Final Environmental Impact Report

505 E. Bayshore Road Project

March 2023

Figure 3.4-2: Existing and Proposed Shadow Conditions - Spring Equinox

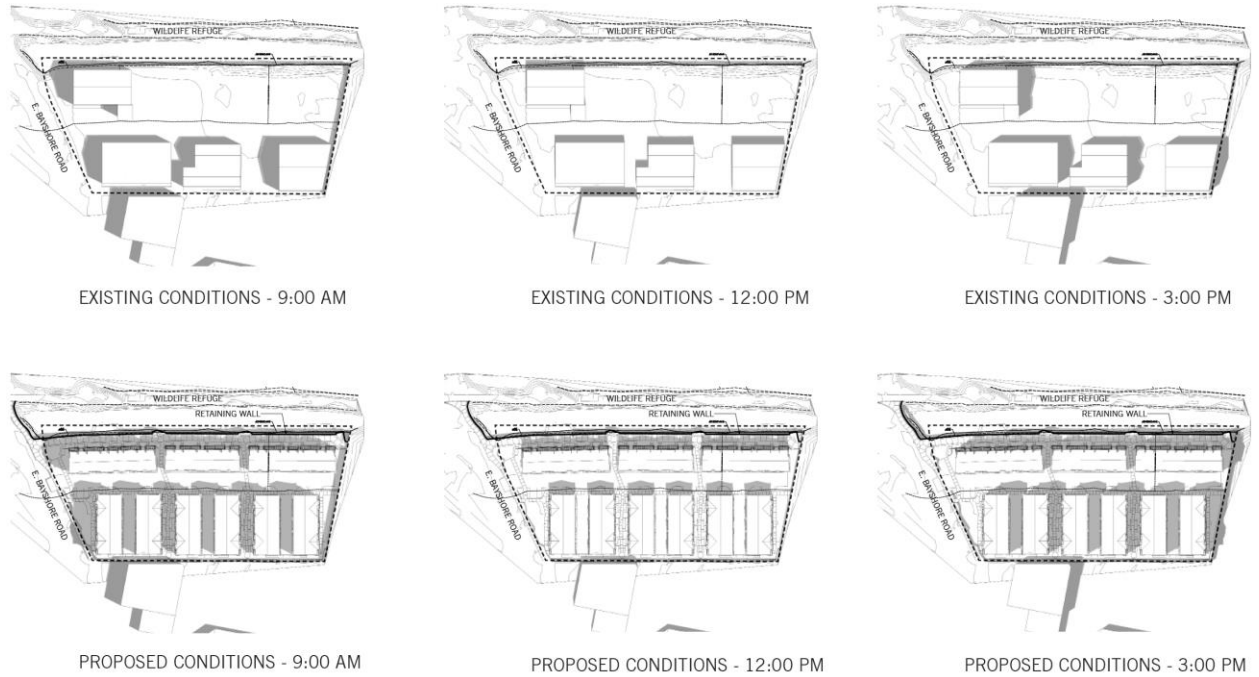
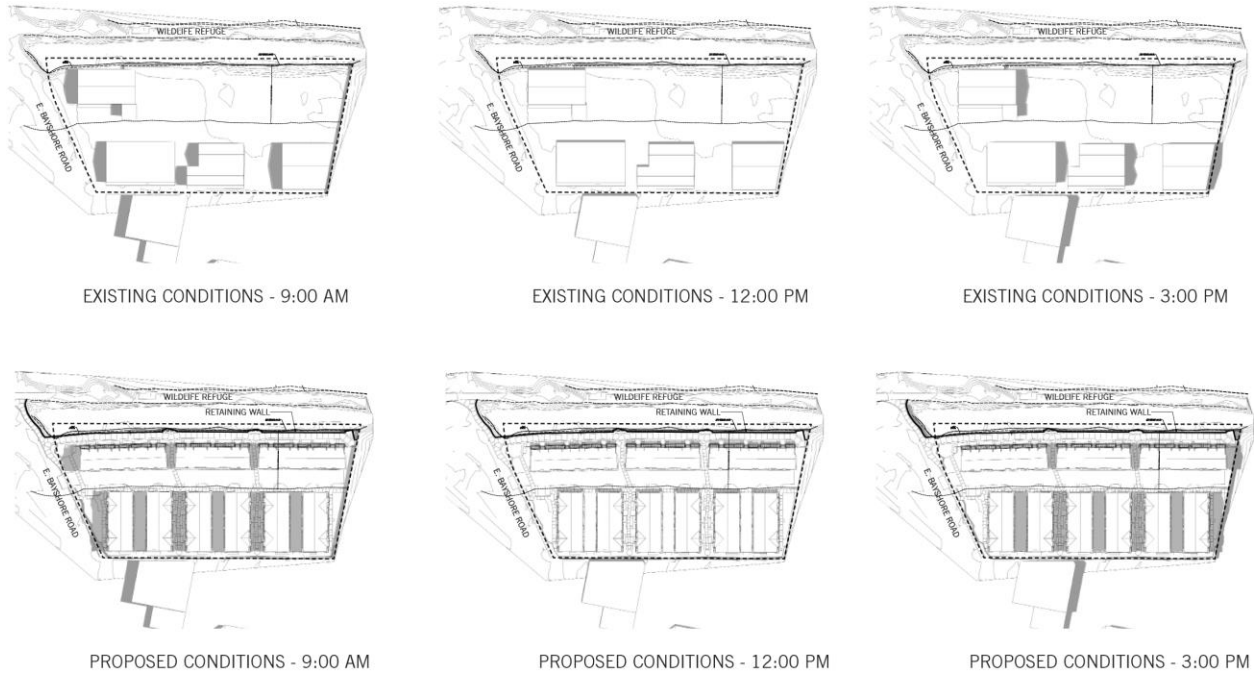
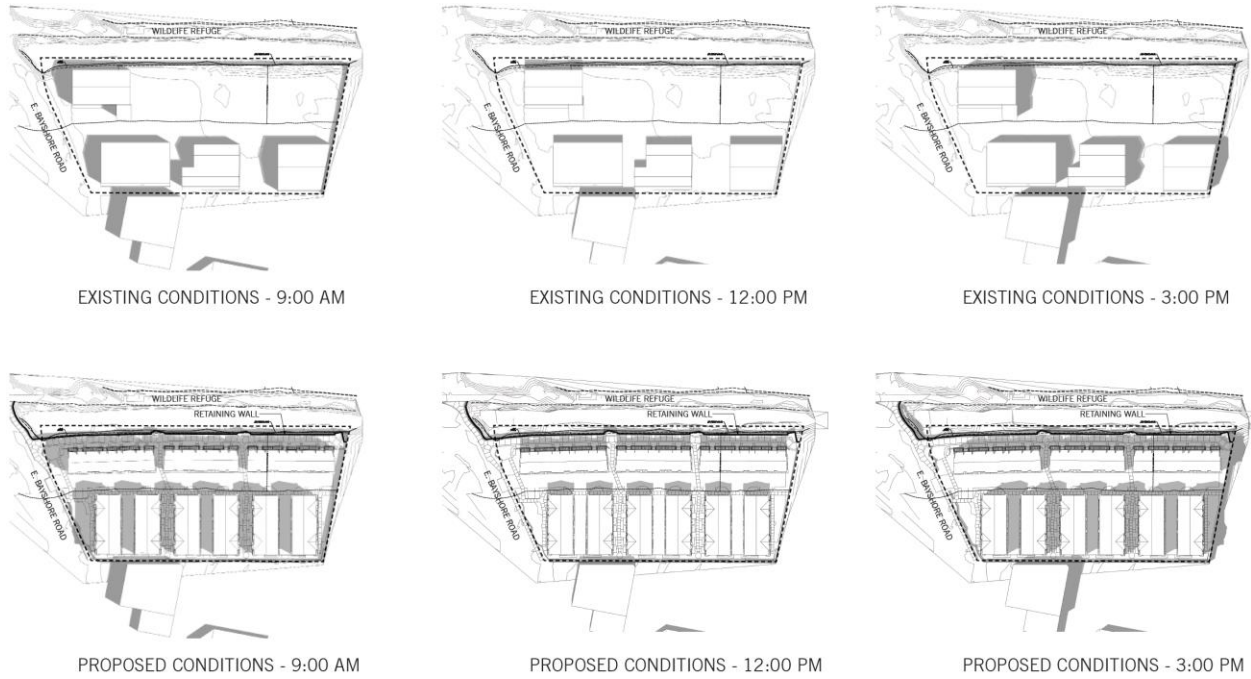
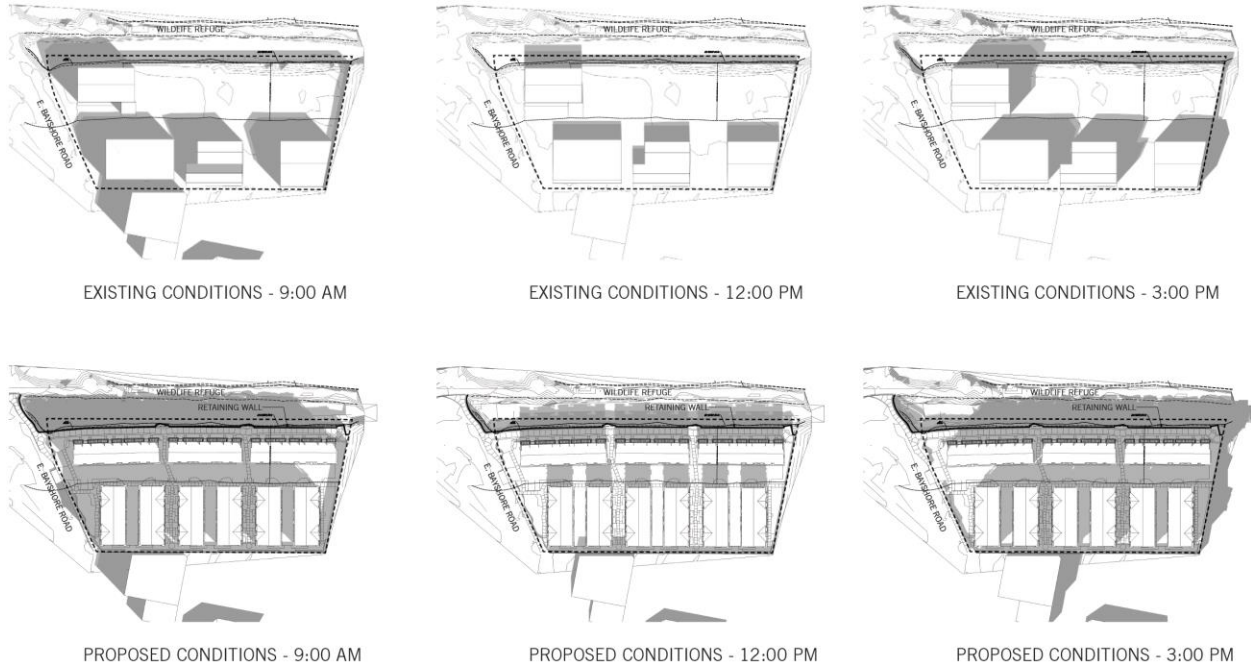
Additionally, the shadow analysis must take into account not only the proposed apartment building height of 38 feet (Project Plans, Sheet A4.10), but also the height of the fill needed to obtain a site elevation 13 feet above mean sea level (DEIR pg. 5), for a total of 51 feet above sea level. This is particularly important because the tidal marsh areas are essentially at sea level.

In conclusion, no shading impacts will occur along the unnamed tidal slough located north of the San Francisco Bay Trail. Shading by the proposed project along the tidal drainage ditch, located south of the San Francisco Bay Trail, will be similar to or less extensive compared to existing conditions for 75 percent of the calendar year, including the peak spring and summer growing seasons. The project will result in increased shading of the drainage ditch during the winter season compared to existing conditions. However, because this increased shading will not affect the peak growing season, and because the habitat quality along the ditch is very low, the effects of this shading on the habitat and any sensitive species that occur there will be extremely limited. Thus, this impact is less than significant under CEQA.

Sensitive Natural Communities in the Vicinity of the Project

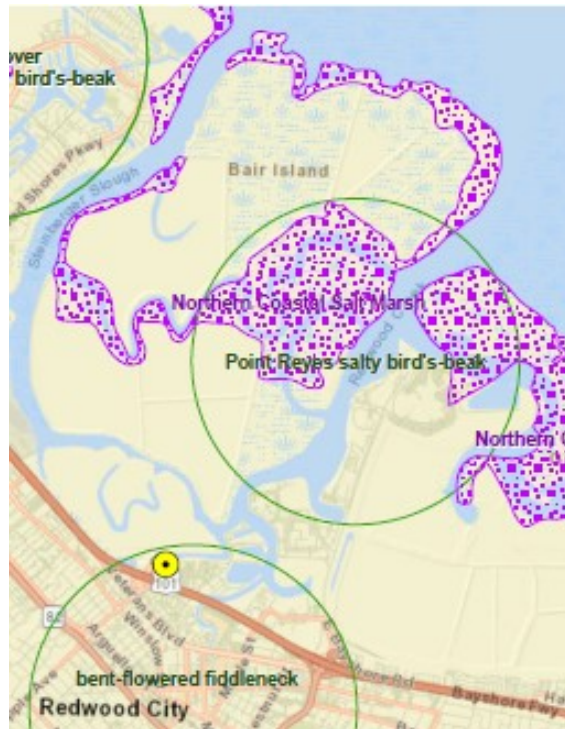
Figure 4. CNDDDB-Mapped Records of Special-Status Plants on page 26 in the DEIR Appendix C shows a map indicating the location of “special-status plant species” and “sensitive natural communities” in the vicinity of the Project site. One of the CDFW-designated sensitive natural communities is Northern Coastal Salt Marsh. This map does not reflect current conditions as it does not reflect the restoration activities that have been ongoing for over a decade. The map incorrectly shows no tidal marsh on Inner Bair Island, and tidal marsh only outboard of the perimeter levees on Middle and Outer Bair Islands. Additionally, there is no Northern Coastal Tidal Marsh depicted along the unnamed slough (a branch of Smith Slough) on the other side of the Bay Trail.

Excerpt from Appendix C, Figure 4, CNDDDB-Mapped Records of Special-Status Plants, which incorrectly shows no Northern Coastal Salt Marsh on Inner Bair Island in the vicinity of the Project. The Project location is identified by a yellow dot on the map.

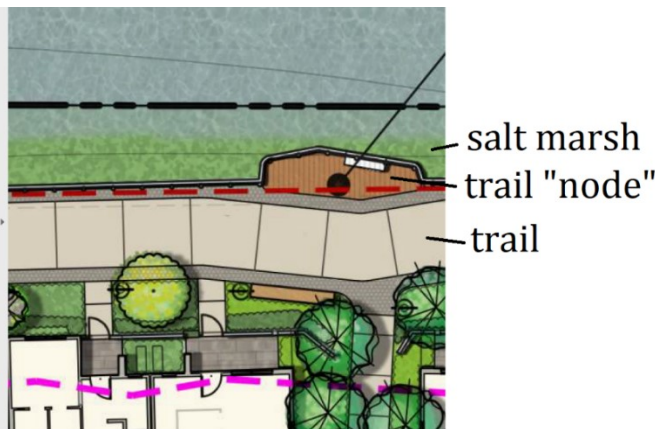
In the absence of a shadow study specifically for impacts to the muted tidal marsh channel and the tidal marsh in the unnamed slough, this conclusion is unsubstantiated. With the close proximity of the buildings (only 29 feet from the edge of the property), the FEIR must include information from a shadow analysis specifically for these sensitive natural areas. The criteria used to determine whether any shade impacts from the buildings are significant must be clearly articulated.

Additionally, the shadow analysis must take into account not only the proposed apartment building height of 38 feet (Project Plans, Sheet A4.10), but also the height of the fill needed to obtain a site elevation 13 feet above mean sea level (DEIR pg. 5), for a total of 51 feet above sea level. This is particularly important because the tidal marsh areas are essentially at sea level.
